ARM720T r4pN Errata List

Document number: ARM720T-PRDC-003802 4.0
Date of Issue: 20 March 2009

This document describes the known errata in the ARM720T r4p3 design.

6.2 Sequential MRC instructions may not execute correctly

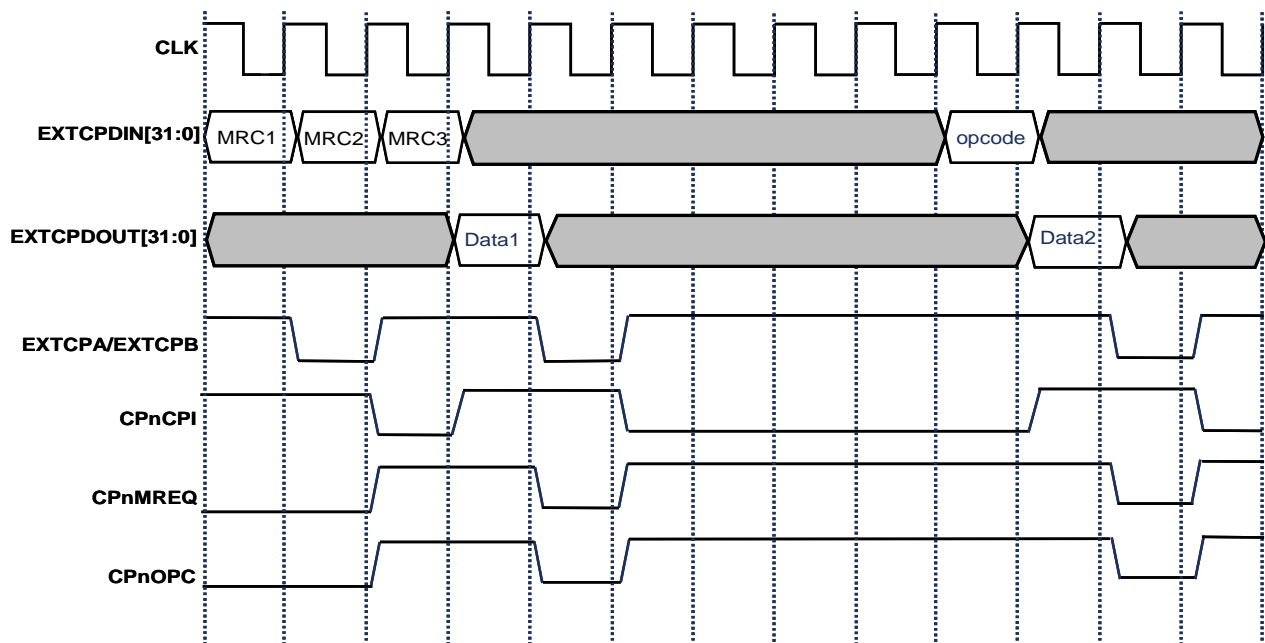
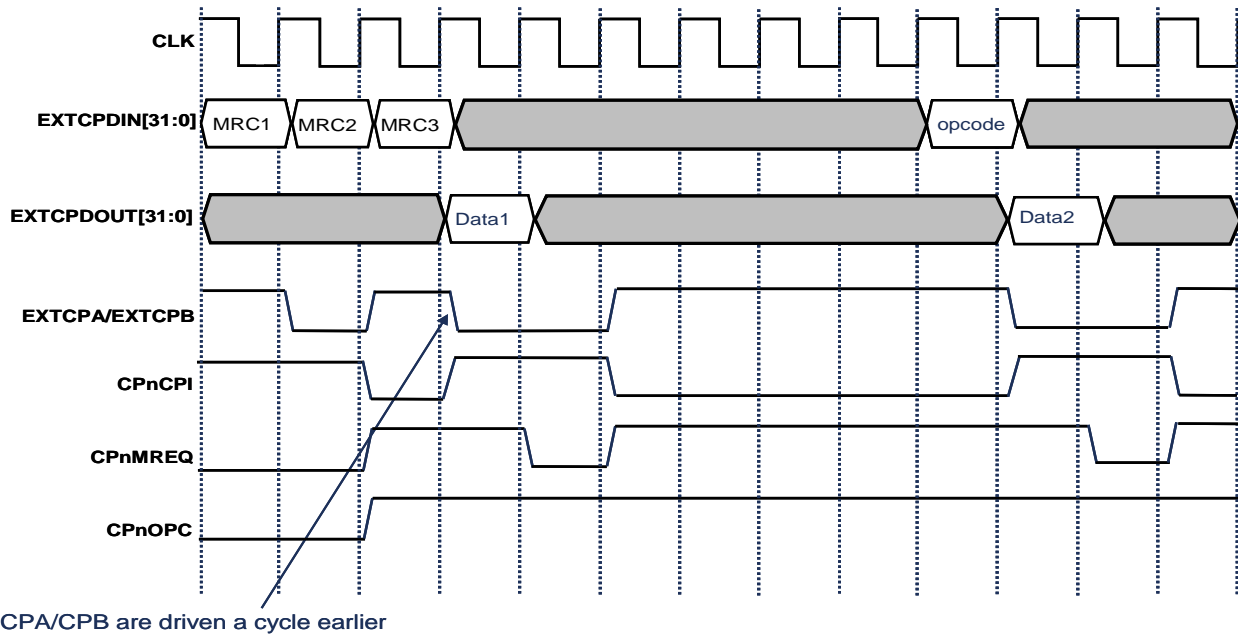
If two or more MRC instructions are fetched sequentially, the second and any subsequent MRC instructions may not be correctly executed by the core.

The bug is only encountered if the value of <opcode_1> is set to 3'bx1x and only if EXTCPA/EXTCPB are being driven low by the coprocessor a cycle earlier with respect to CPnOPC/CPnMREQ going low. The bug only affects external coprocessor accesses and not internal CP15 operations.

Figure 1, shows how EXTCPA/EXTCPB are driven in the AVS testbench, causing the bug not to trigger.

Figure 2, shows how the bug is triggered, e.g. when EXTCPA/EXTCPB are driven a cycle earlier by the coprocessor.

- 1: Delay EXTCPA/EXTCPB inputs by a full clock cycle, e.g. so that they are taken low when CPnOPC/CPnMREQ go low.
- 2: Insert a NOP instruction between each MRC instruction that appear in program code, there will be an overhead of an additional instruction for each sequential MRC instruction fetched and executed by the core.
